General Service Bulletin

Condensate Trap Tubing Interference in Horizontal Left/Right Applications

Models:

ORDER No: FURN-SVB055A-EN

Figure 1

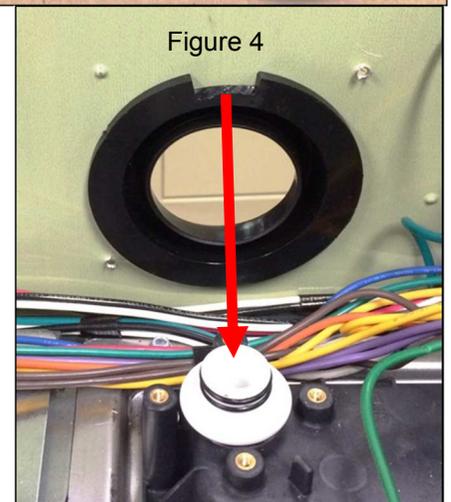
This is a “mandatory” rework for installed furnaces in horizontal left/right applications only. Interference between the horizontal condensate grommet and the condensate trap’s lower connection may not allow the tubing to be fully seated on the “C” width furnace models listed above. (See Figure 1) The action described in this bulletin is not being taken to address a safety concern.

It has been determined that the horizontal condensate grommet creates interference with the rain gutter tubing and doesn’t allow the tubing to be fully seated on the condensate trap’s lower port when the “C” width (21.0”) furnace is installed in the horizontal left/right position. Due to the tubing not being fully seated, there is potential for condensate to leak at this connection.

An improved condensate grommet is being designed to eliminate the interference between the grommet and condensate trap. In the meantime, the current condensate grommet will need to be modified before installation. Affected furnaces that have been installed will need to be re-worked following the corrective actions listed on page 2.

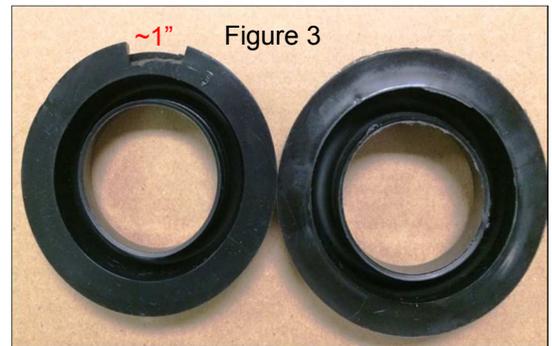
1. For installed furnaces, disconnect power to the furnace
2. Remove the furnace door
3. Remove tubing from the condensate trap (See Figure 2)
 - Condensate pressure switch tubing

9. Reinstall condensate trap onto the cold header.
10. Use (2) screws from Step #4 to attach the trap to the cold header. Do not over tighten screws.
11. Re-connect the tubing to the condensate trap (See Figure 2)

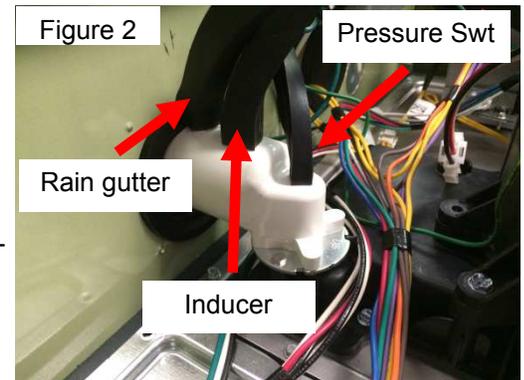
7. Cut a notch approximately ~1" wide x 1/4" deep into the condensate grommet. (See Figure 3)
8. Reinstall condensate grommet into the furnace and align the notch with the condensate outlet of the cold header. (See Figure 4)
